Cal Pacific Airmotive, Inc. **Mandatory Service** Revision: 0 **Bulletin Title:** Inspection of Flight Control System

North American Aviation P-51B, P-51C, P-51D, P-51K, F-51D, F-51K S.B. No. P51-001

Cal Pacific Airmotive, Inc.	I Manualui V Sei Vice	S.B. No. P51-001 Supplement No. 1
Title: Inspection of Flight Control System	North American Aviation P-51B, P-51C, P-51D, P-51K, F-51D, F-51K	Issue Date 5-1-2013 Page 1 of 2

PIGGRE 90- INSTALLING ALLERON TRIM TABS REVISED UNDER LIC-11-5 MAY 1 2013

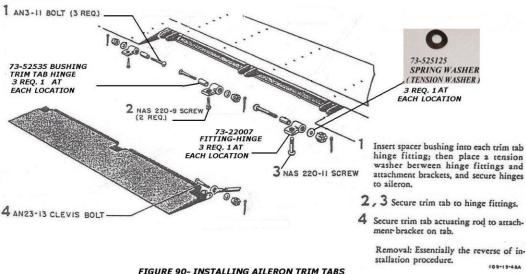
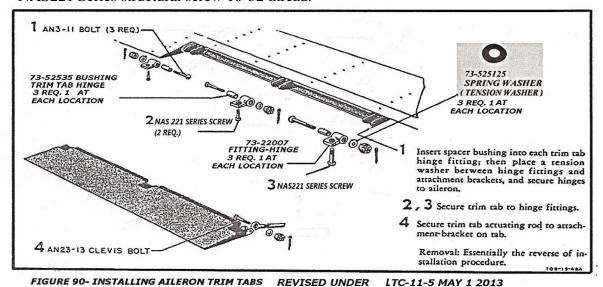
Supplement No. 1 to Service Bulletin P51-001 dated May 1, 2013 is to correct information contained in AN 01-60JE-2 Handbook Maintenance Instructions USAF Series F-51D, ZF-51K, F-51M, TF-51D dated December 20, 1944, revised December 20, 1952. Handbook page 84 figure 90 "Installing Aileron Trim Tab" incorrectly notes P/N NAS220-9 and NAS220-11 (8-32 thread structural screws) to be installed in spline nut P/N 22D8-02 (or 22ND8-02) 10-32 thread. This spline nut is installed in each of the trim tab hinge fittings P/N 73-22007.

3. Attach this Supplement No.1 to Service Bulletin P51-001 dated May 1, 2013 to update page 7 figure 90 "Installing Aileron Trim Tabs" with figure 90 below to reflect the correct P/N NAS221 Series structural screw 10-32 thread.

- 1. Refer to Parts Catalog AN 01-60JE-4 USAF Series F-51D, TF-51D and F-51K Aircraft dated March 10, 1945, revised May 15, 1953, page 20D figure 4B "Aileron Assembly" index no. 33 to install the correct part number structural screw NAS221 series (10-32 thread). This parts catalog is also reference for the P-51D thru P-51K aircraft. Length of screw may vary from those published in the North American Aviation & USAF maintenance and parts manuals if trim tab is original, rebuilt, phenolic or metal covered.
- 2. When installing structural screws to secure the trim tab to the hinge fitting P/N 73-22007, make sure the screw shank does not bottom in the threads of the spline nut and at least one full thread extends through the locking nut insert.

- 4. Apply the enclosed adhesive back revised figure 90 to AN 01-60JE-2 Handbook Maintenance Instructions for USAF Series F-51D, ZF-51K, F-51M, TF-51D dated December 20 1944, revised December 20 1952, page 84 figure 90 "Installation of Aileron Trim Tab" to reflect the correct structural Screw P/N NAS221 series 10-32 thread. Also update other manuals as may be deemed necessary.
- 5. Use good maintenance practices to determine proper application of data from any USAF or NAA Technical Manual for P-51 series aircraft.

FIGURE 95-- INSTALLING ELEVATOR AND RUDDER TRIM TABS REF. MAINTENANCE INSTRUCTIONS PAGE 88 AN 01-60-JE2 FIGURE B

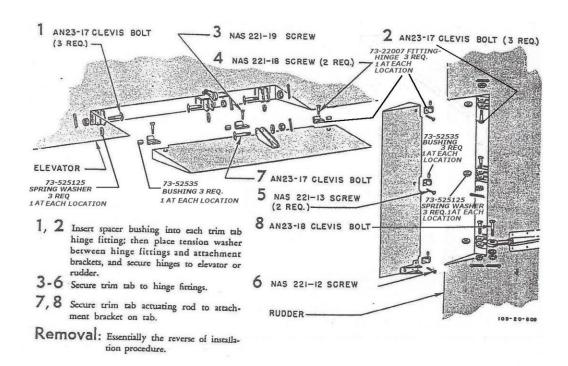
- 5. Install P/N 73-525125 spring (tension) washer when attaching the trim tab hinge fitting to the control surface, at all locations. Per NAA drawing, confirm washer is approximately .020-inches thick, inner diameter 1/4-inch, outer diameter of 9/16-inch and a spring bow of 1/16-inch, made from 1095

- spring steel or equivalent. Bushing P/N 73-52535 (length .475 +/- .002) will extend into the spring washer when properly installed. Refer to Figure "B" attached.

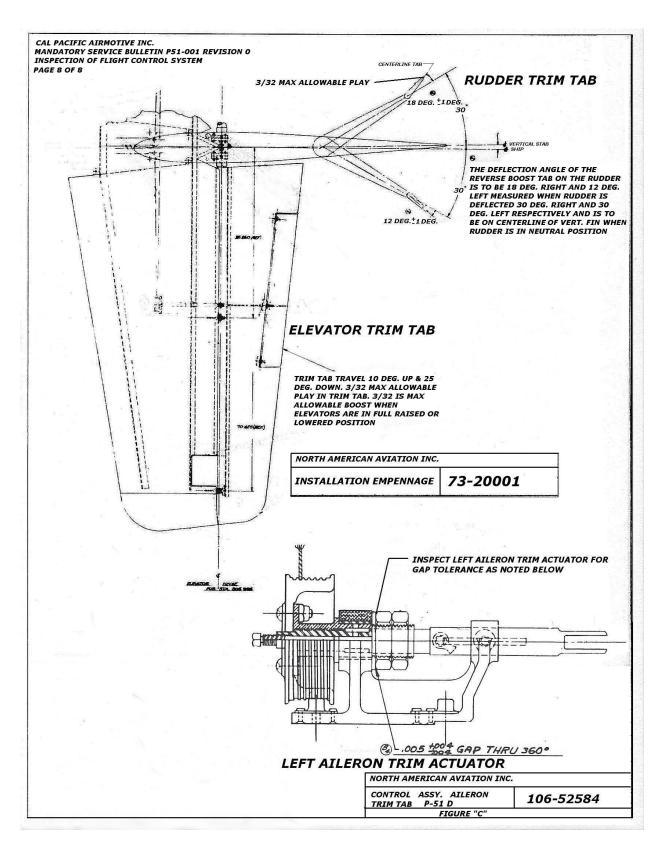
- 7. Inspect rudder and elevator trim tab for free play not to exceed 3/32-inch max allowable play in accordance with NAA drawing No. 73-20001. Repeat same inspection for aileron trim tabs. See figure "C" attached.

- 8. Inspect Control assembly-Aileron trim tab (Actuator -left aileron) for gap tolerance in accordance with NAA drawing no. 106-52584, parts catalog AN 01-60JE-4 figure 49-21 and figure "C" attached for the P-51D only. For P-51B/C aircraft control assembly P/N 102-52584 is not adjustable. If excessive play is present it is due to worn parts, replace as necessary.
